## Comments on Tech Note 23 Assessments for Yakima County 2015 to 2021

Friends of Toppenish Creek - August 1, 2021

1. This is the WSDA Map that the agencies use for determining Aquifer Susceptibility to pollution from lagoons<sup>2</sup>.

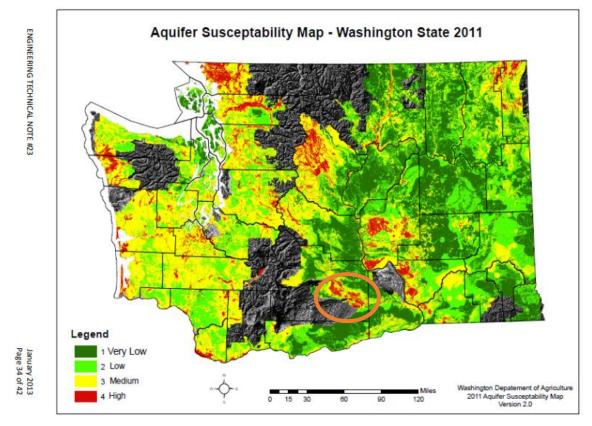
Much of the Lower Yakima Valley falls into the "High" category. But none of the dairies in this study had an aquifer susceptibility score greater than 3 - Medium. (See Columns U & BF) This indicates a tendency to downplay problems associated with manure lagoons.
